Phase VII Sideslope Closure CDF Slurry Wall Landfill Change Order No. 2

## CHANGE ORDER FORM

NO. Two (2)

PROJECT NAME: CDF Slurry Wall Landfill Phase VII Sideslope Closure

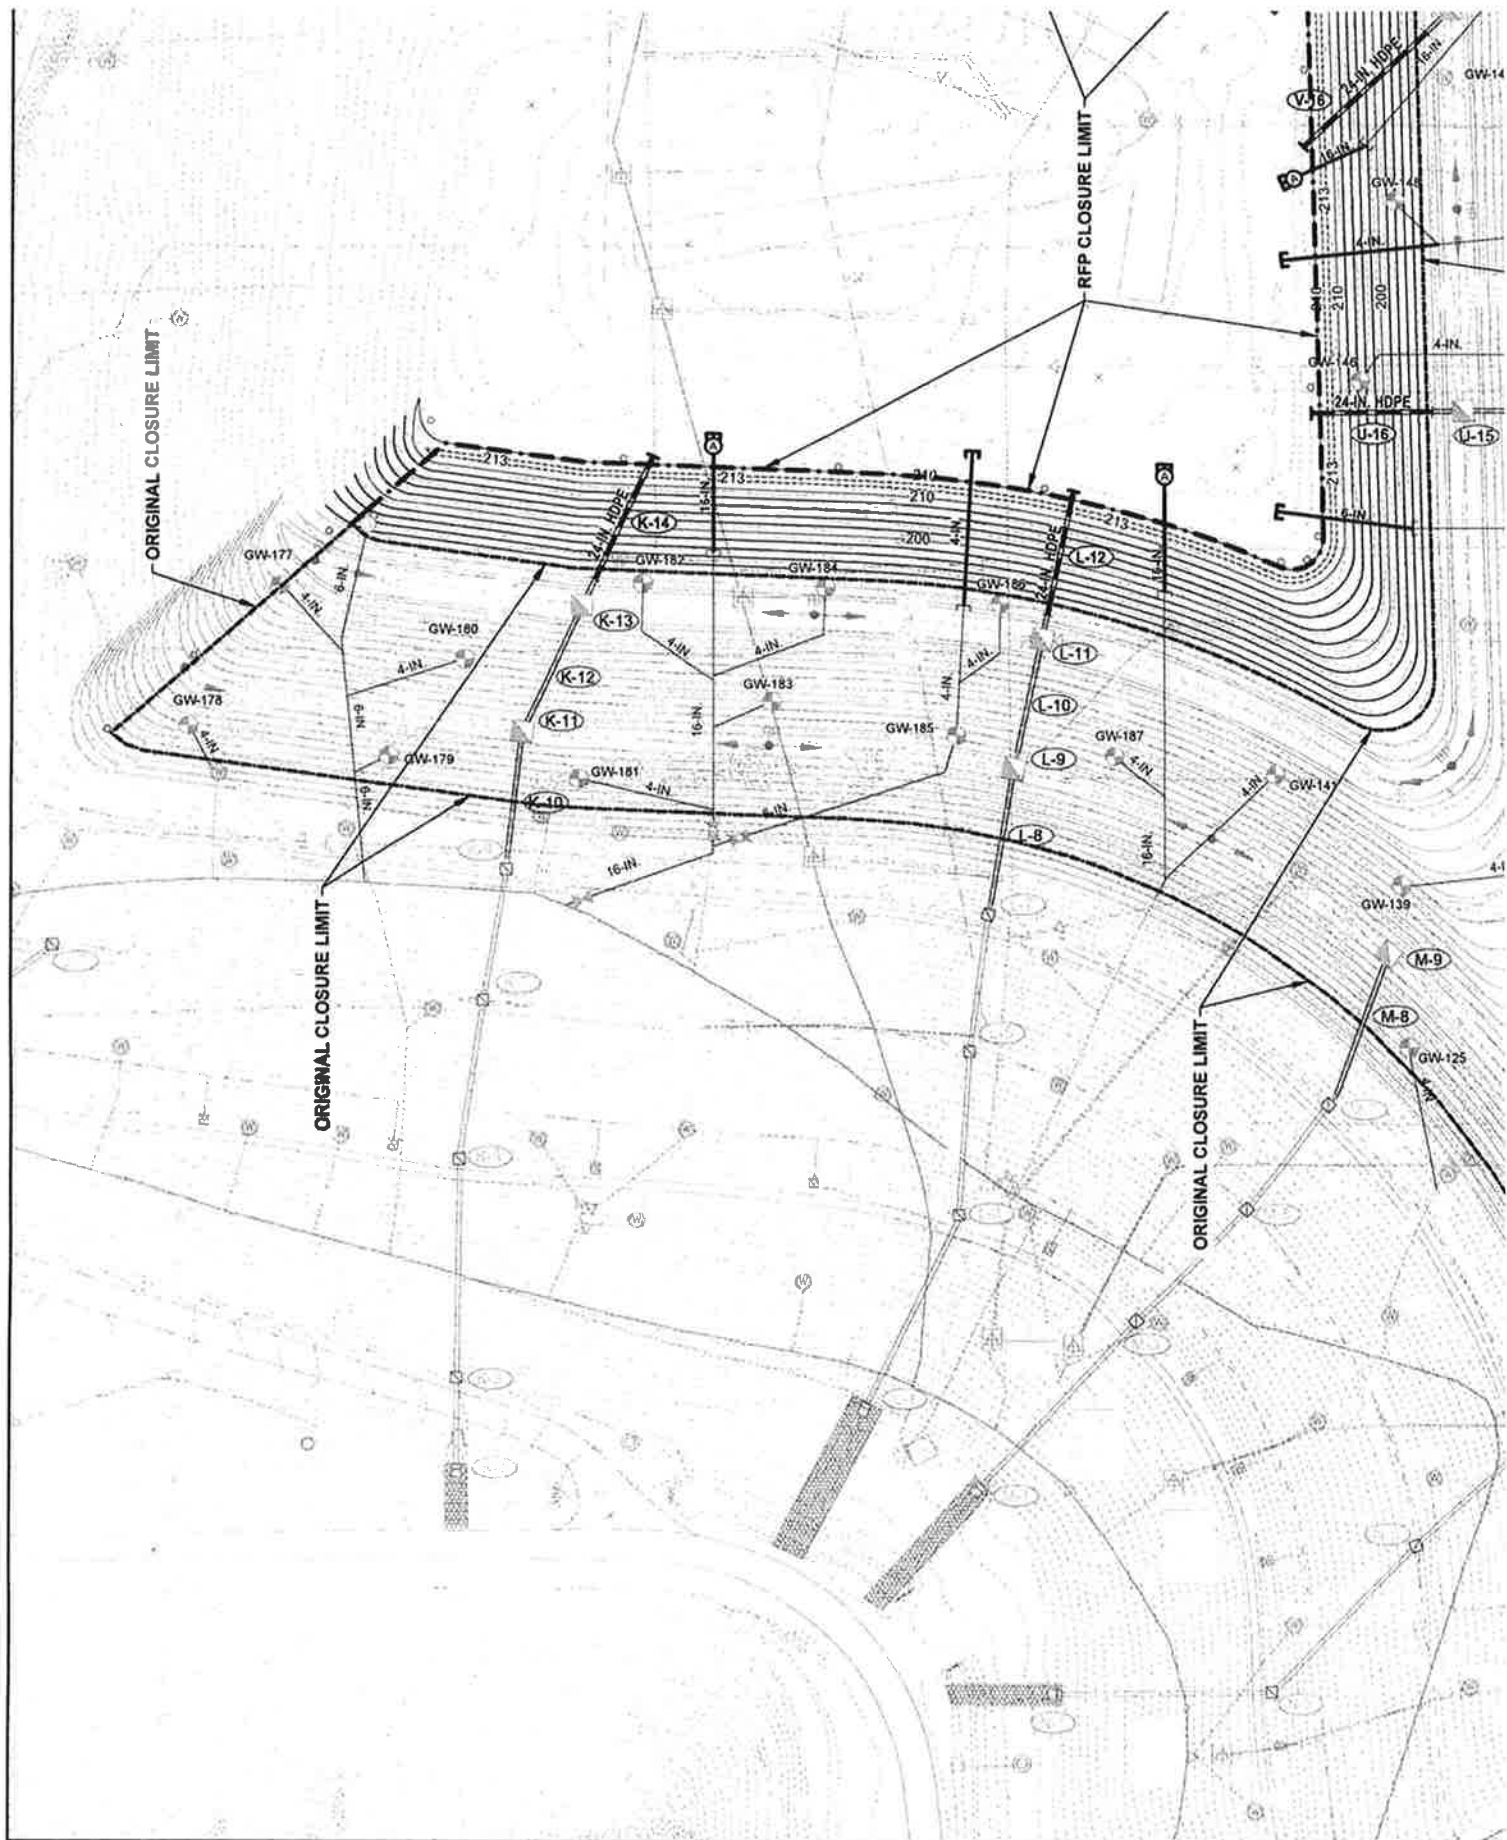
An updated topographic survey of the Slurry Wall Landfill (SWL) indicated an area on top of the contracted closure construction area will be vulnerable to erosion and washouts and will require to be stabilized or closed as part of this project. The adjustments to the closure cover system and final grading plan are based on site conditions at the time of construction. Adjustments to the final closure cover area are intended to prevent erosion and washout of solid waste on the newly closed side slope areas. In addition, extension of the stormwater letdown pipes, inlets and landfill gas piping are included to the new limits of closure.

Please prepare a detailed proposal for extension of the closure construction area to the limits shown on the attached drawing. The additional work includes, but not limited to, solid waste grading and preparation of the new areas for installation of the Leveling Course, 40-mil LLDPE liner, CDN and 24-inches of protective cover with sod. The LFG laterals and collection pipes are to be extended to new limits, new stormwater inlets installed at the 210-ft terrace and letdown pipes extended and capped.

**A** **RESPONSE TO CCIR - 6**  
N.T.S.

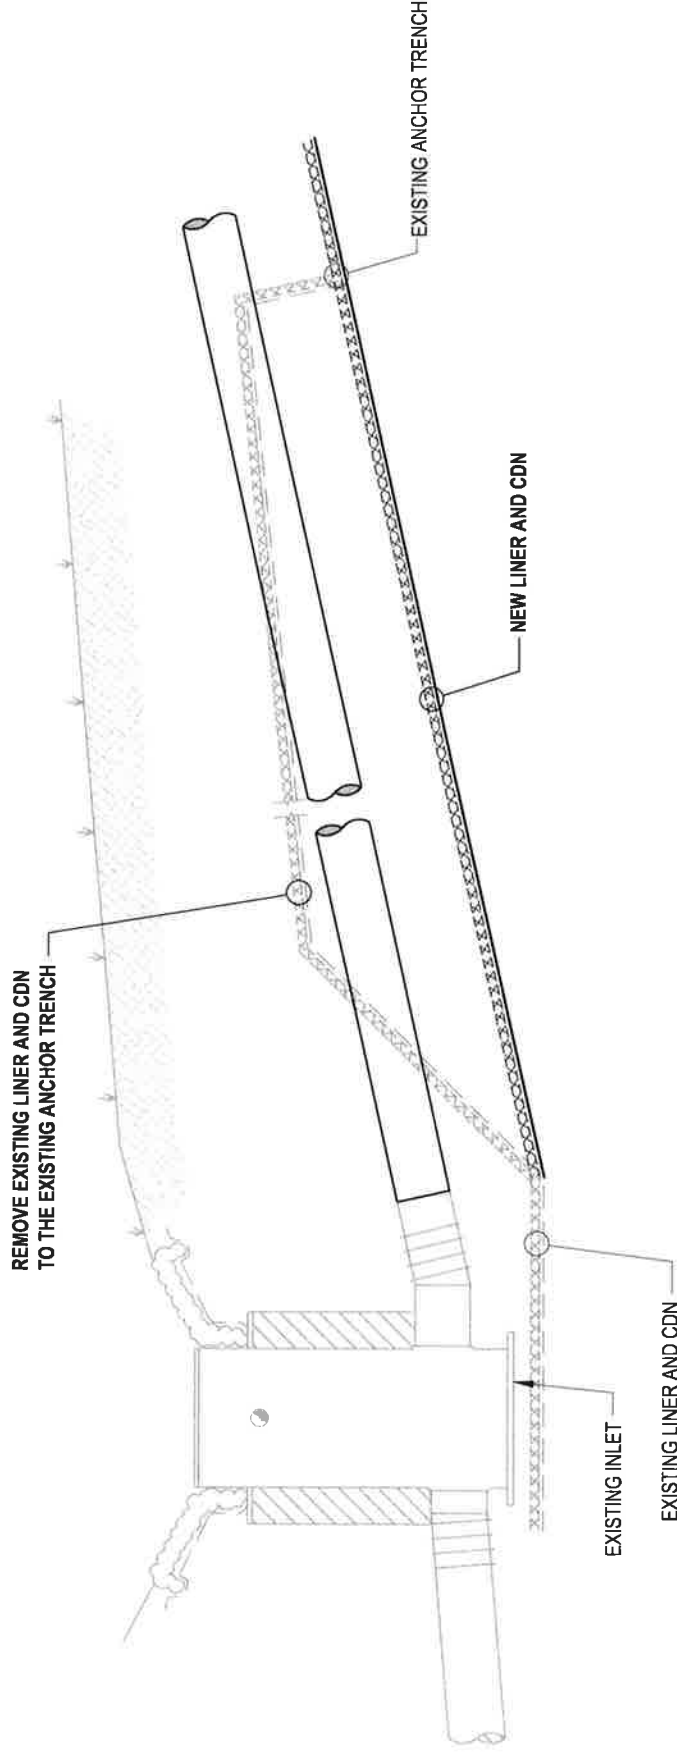
The project requires exposure of the existing stub-outs up slope of the existing stormwater inlets and connect the new letdown pipes to the limits of construction. The excavation at a few of the inlets shows the pipe trench was not installed after the stub-outs. This requires the previous closure cover along the alignment of the new letdown pipe be opened and build a trench for installation of the letdown piping. Reference CCIR-6 Response.

Please prepare a detailed proposal for cutting the pipe trench in areas where needed in order to extend the letdown piping. The proposal should detail the work required to excavate the waste along the proposed trench, install new liner and CDN for the letdown pipe to be installed as shown in the attached detail A. The pipe and connections to the existing stub-outs were previously included in the contract.

In addition, please include in your proposal detailed cost breakdown to extend the letdown pipe to the proposed anchor trench as shown in the attached drawing B.

1. EXPOSE THE UPSLOPE STUB OUT ON EXISTING INLET STRUCTURES. CLEAN AND PREPARE AROUND THE EXISTING STUBOUT FOR CONNECTION TO THE NEW PIPE. PROTECT THE FABRIFORM FROM DAMAGE.
2. EXCAVATE A PIPE TRENCH (DETAIL-30) UPSLOPE FROM STRUCTURES B-9, A-9, V-11, U-11, T-11, M-7, L-7, AND K-9 TO THE EXISTING ANCHOR TRENCH.
3. INSTALL LINER SYSTEM FOR THE ENTIRE OPEN UP TRENCH AND WELD TO THE EXISTING LINER.
4. CONNECT THE NEW LETDOWNPIPE TO THE STUB-OUT USING SPLIT COUPLER (DETAIL 32)
5. BACKFILL, COVER AND SOD TO MATCH THE PREVIOUSLY CLOSED AREA AS REQUIRED.
